From: Marine Licensing <marinelicensing@cyfoethnaturiolcymru.gov.uk>
Sent: 19 March 2025 08:22
To: Anna Ntasiou; Marine Licensing; Marine Area Advice and Management Team
Cc: Ian Meyrick; David Short
Subject: RE: Q24031 MHWS line in Bangor

Subject: RE: Q24031 MHWS line in Bangor

I am currently working on a coastal infill works design in Bangor. The location where the infill works will take place is shown in the red circle below, and is next to the existing sewage pumping station and the new seawall that has recently been installed by the Gwynedd Council.

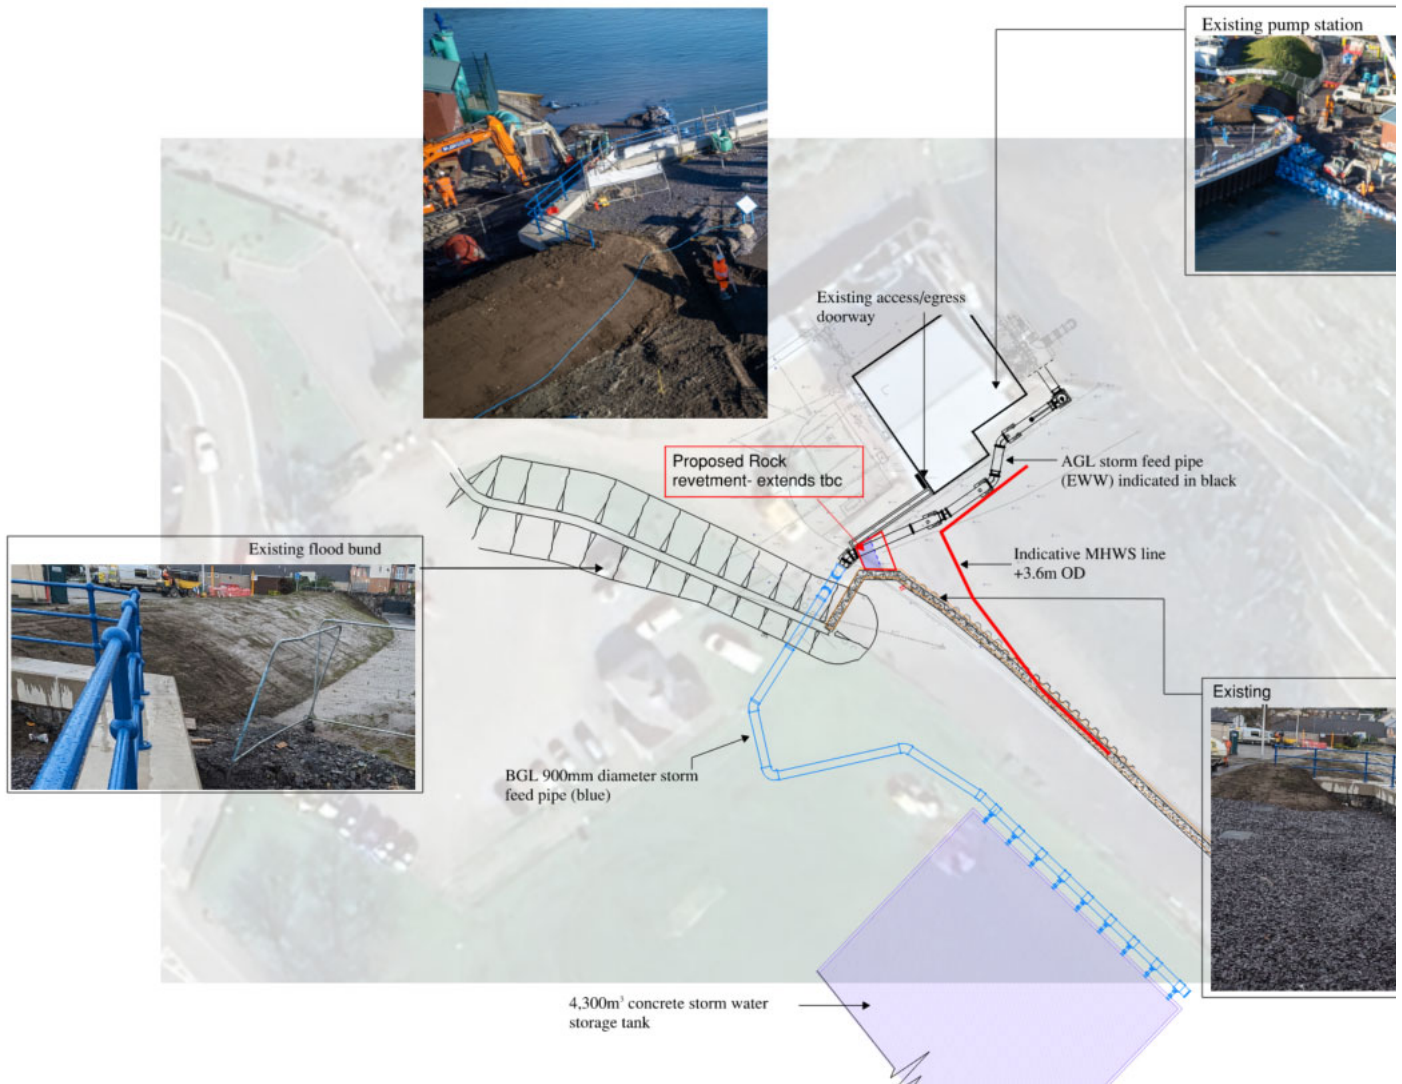
The scheme has now been updated and what we propose as coastal erosion works, is a rock revetment (see indicative example on the photo below) located at the corner between the existing seawall and the existing revetment around the SPS, please see snapshot below. The extent of the revetment on the seaward side will be confirmed at a later stage. Previously, I had sought your confirmation regarding the location of the MHWS. I had calculated it by using publicly available sources, I had also looked at the NRW website [WOM21 Wales High Water Mark | DataMapWales \(gov.wales\)](https://www.gov.wales/wom21) and I had marked the MHWS line at +3.6m OD as per the snapshot below, which denoted that our works are landwards of the MHWS line and hence, no marine license would be required.

However, from drone photos that were taken recently on site, it appears that the MHWS line reaches the top of the corner, please see photo below. This aligns with what Joe had told me (please see email thread below) about the google earth images showing the MHWS line further landwards from what my plan sketch was indicating.

Hence, my understanding is that we will require to obtain a marine license for the rock revetment works we propose. Therefore, we would like to have a pre-application consultation meeting with you, to confirm :

Section D-D: Embedded RC L Shaped Stem Wall

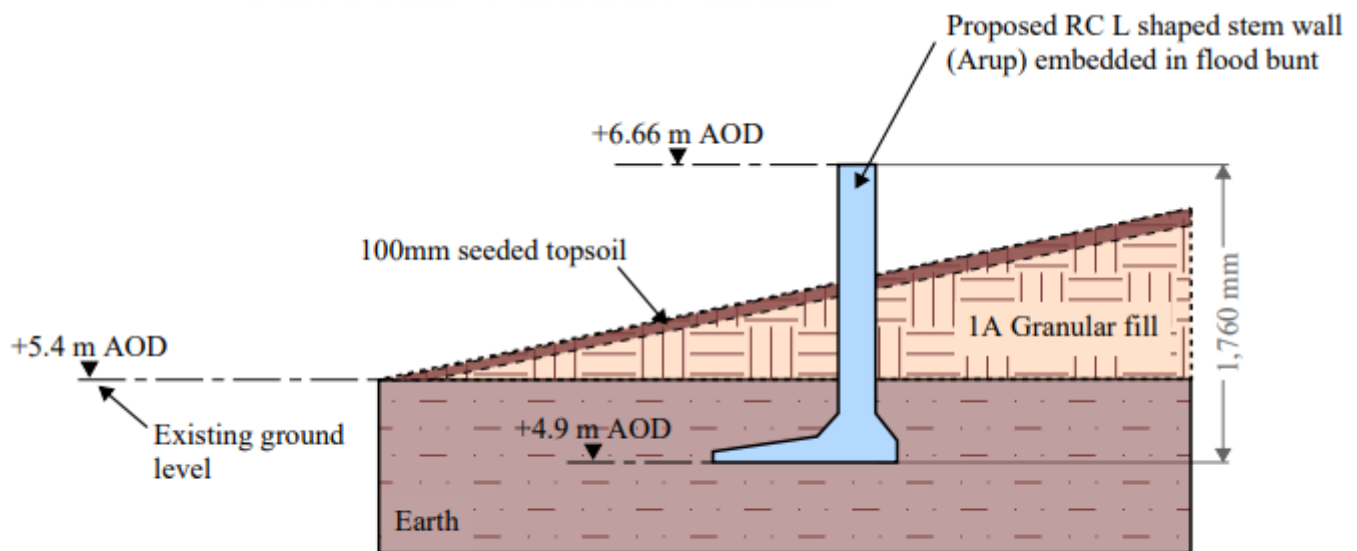
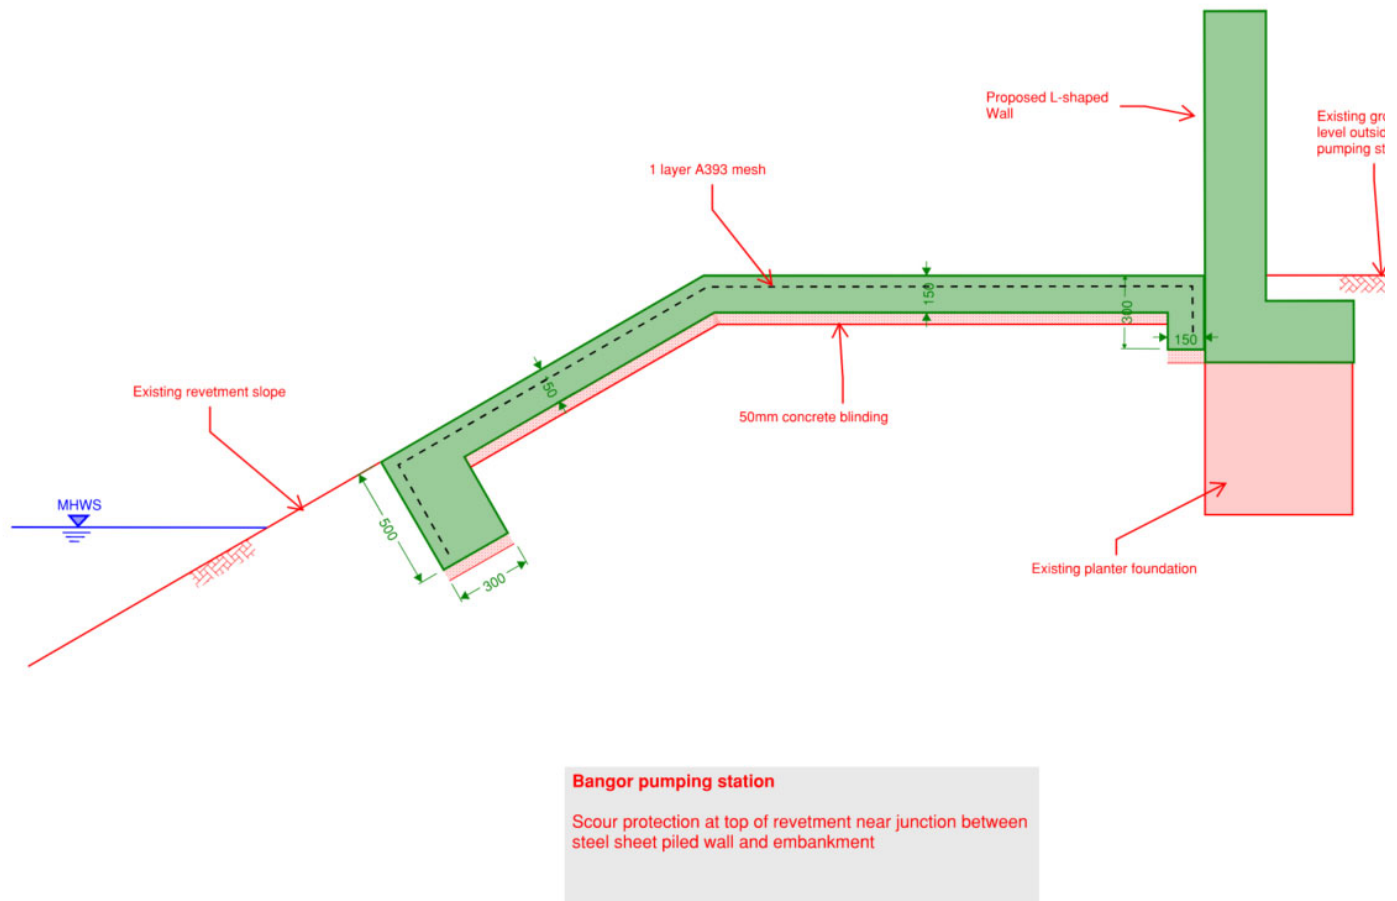
- 1) Proposed RC L-shaped wall on the landwards side of the existing revetment. This wall will tie into the existing flood bunt- Please see snapshots below of the Work in Progress Draft sketches we currently have.

We understand that the scour protection works that we are proposing are landwards of the MHWS the way we have calculated it, please see attached plan and the email thread below for reference.

- Whether we need a marine license for the scour protection works, as we deem it to be way landwards of the MHWS
- Whether we require a flood risk activity permit for the scour protection works as it is near the seawall
- Whether we require a flood risk activity permit for the proposed RC L-shaped wall finishing at the flood bunt
- In the case we need the above, could you please let us know whether we could cover both Marine License and Flood Risk Activity Permits under the same license or do we need to apply for a Marine License and FRAPs separately?

If you are confident that the works areas for both the scour protection and new wall are landward of MHWS, then they do not fall within the marine licensable area and therefore, a marine licence would not be required for these works.

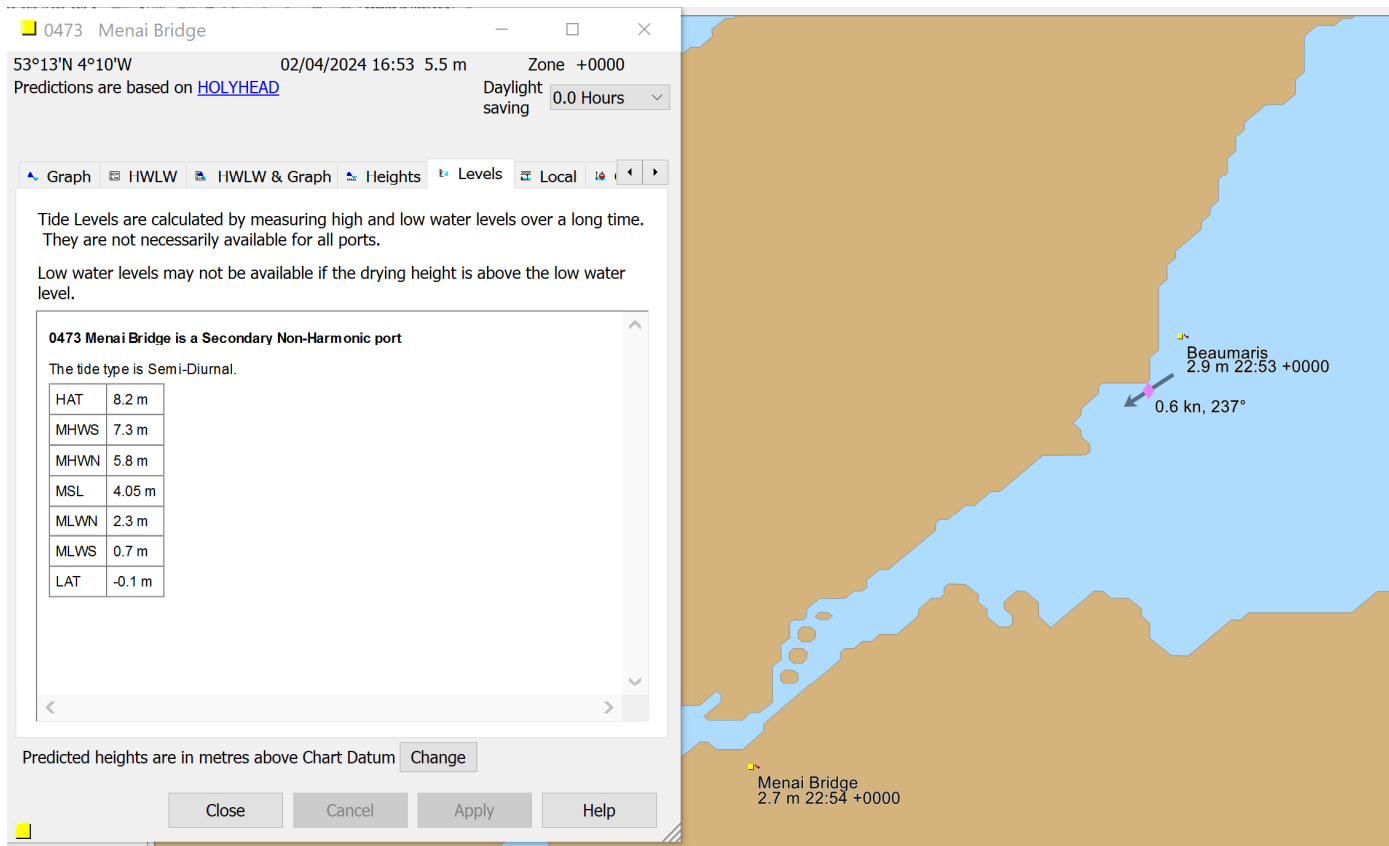
Thank for providing the evidence for where the MHWS line is. I have also had a look at satellite images which appears to show a strand line very near to where the works are taking place indicating the high water mark being above where you have indicated. See below.

Ultimately it is for you to ensure that you have the correct permissions in place prior to carrying out the works and if any works are taking place seaward of MHWS then a marine licence would be required.

WOM21 Wales High Water Ma

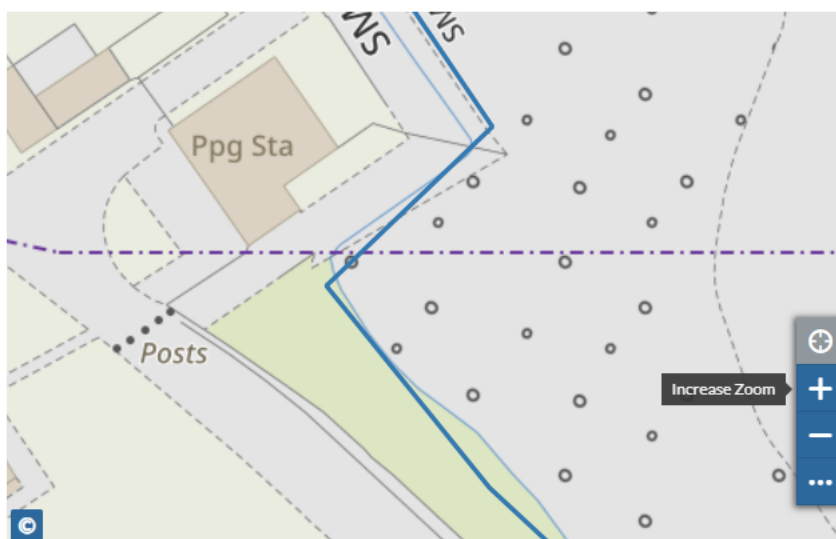
Currently, the Government of Wales website shows the MHWS line further seawards from the location of interest, please see snapshot from link below:

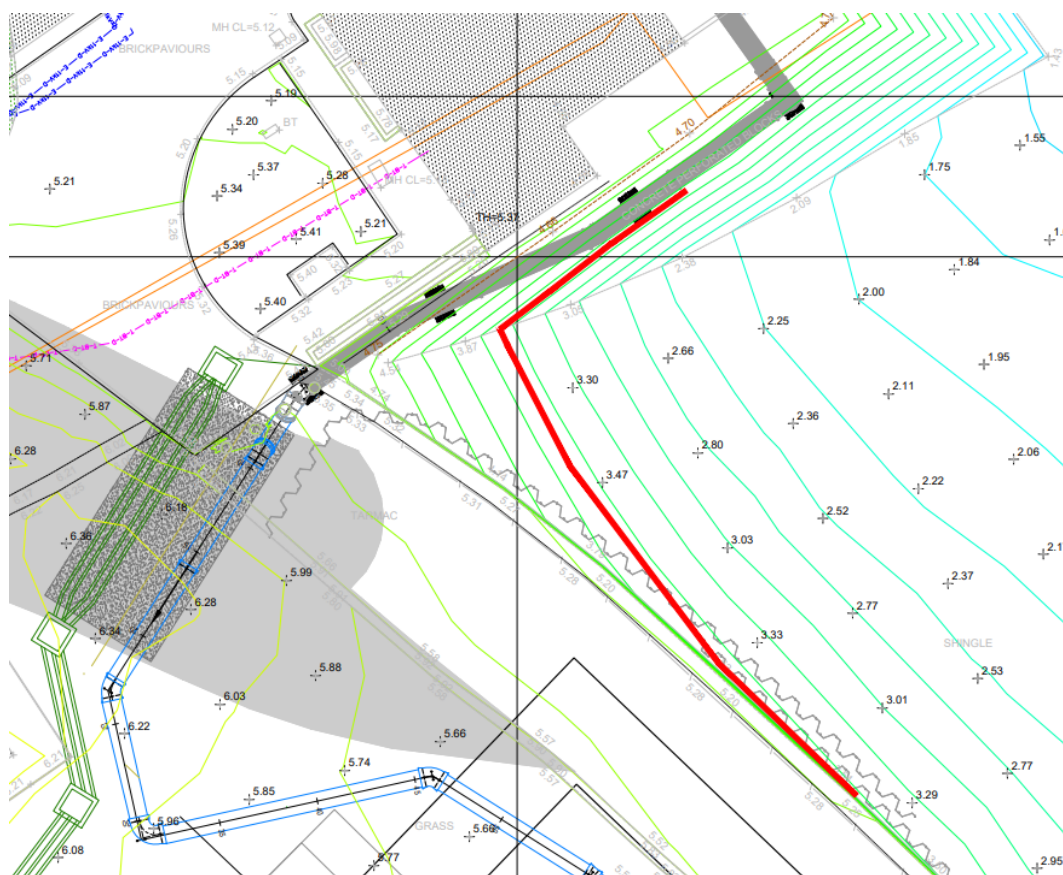
I have also found information on the MHWS tidal level from a nearby location, Beaumaris, which shows the MHWS line at +3.6m OD and I have plotted it against the existing topographic survey, please see red line in the snapshot below.

My understanding is that our works fall landwards of the MHWS lines and hence, a marine license is not required. Could you please advise on whether a marine license is needed as well as the type of marine license?
